<b>Change Note</b>		<b>CN-070</b>
<b>Change to:</b> Technical Assumption 55		
<b>Description:</b> Cold water supply pressure		
<b>References:</b> All tests, Test regime paragraph 2.13		
<b>Change originator:</b> IR		<b>Date of request:</b> 17/11/21
<b>Rev:</b> 01	<b>Date authored:</b> 17/11/21	<b>Proposed change to assumption:</b> Yes

Drawing reproduced by courtesy of  
RISE Research Institutes of Sweden

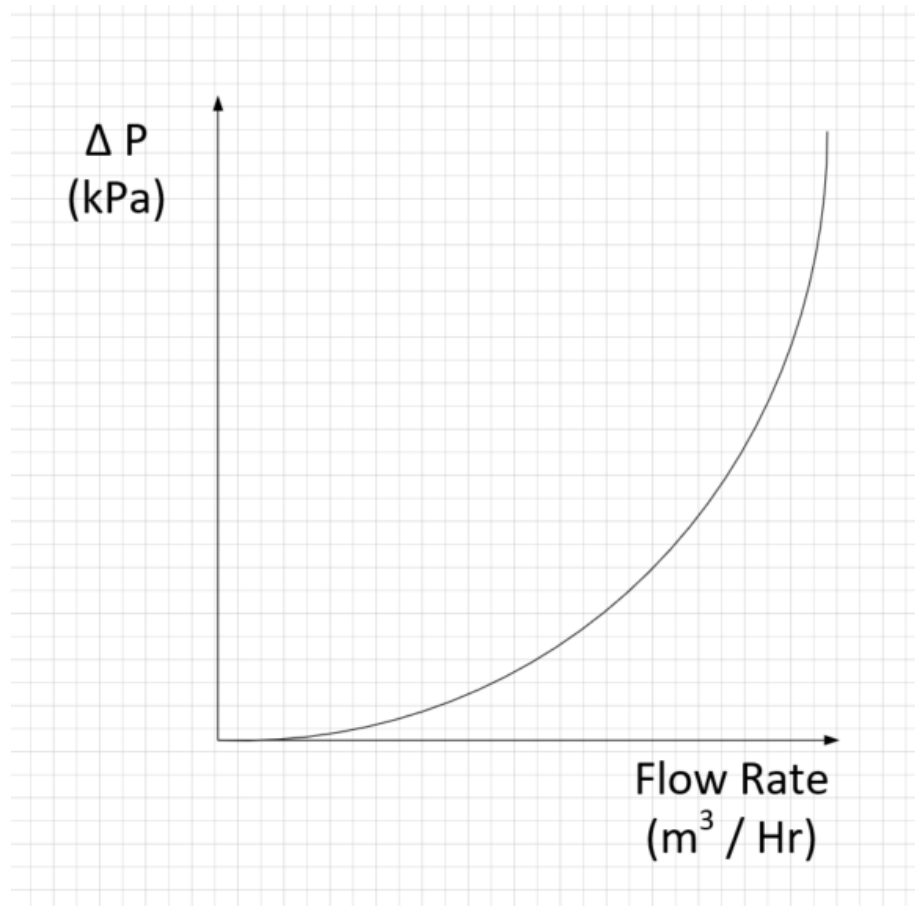
The dynamic DHW test pressure should be increased to 3 bar g across all hot water tests. However, to try to prevent designers overengineering the boosted mains systems, it is recommended that only the pressure drop across  $\Delta P_3$  (See below Figure) should be logged and reported against the corresponding flow rate in the form of a graph as seen below.

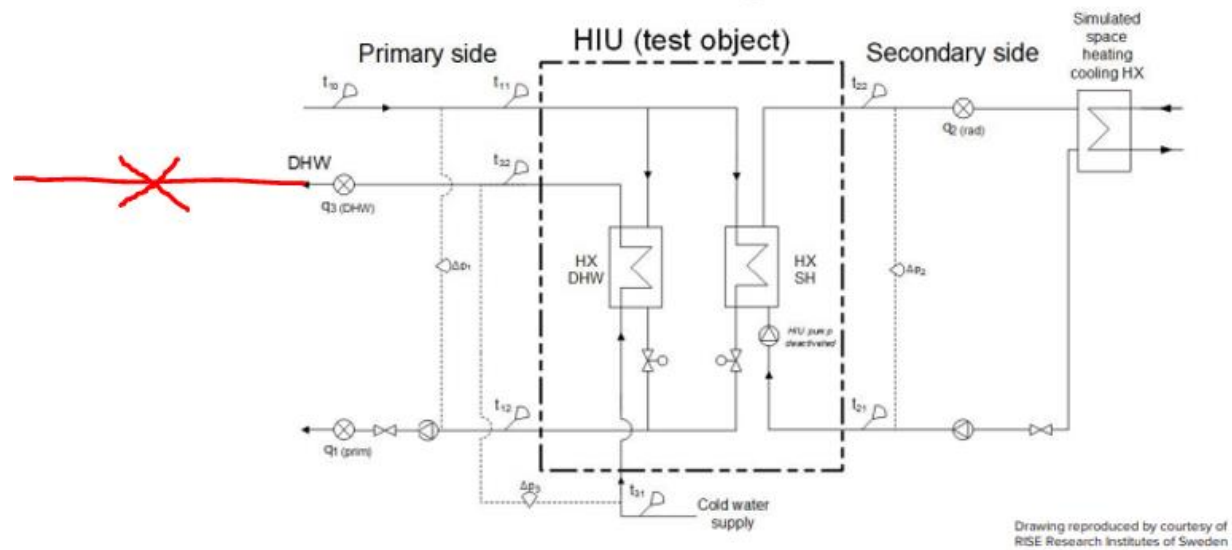
It is important that the regulating valve is positioned at the end of the line as shown below by the red X in the figure below. If the adjustment valve is positioned in front of the HIU the pressure transducer that is positioned after the HIU will register a pressure close to atmospheric pressure and give a falsely low reading, resulting in an incorrect high pressure drop figure.
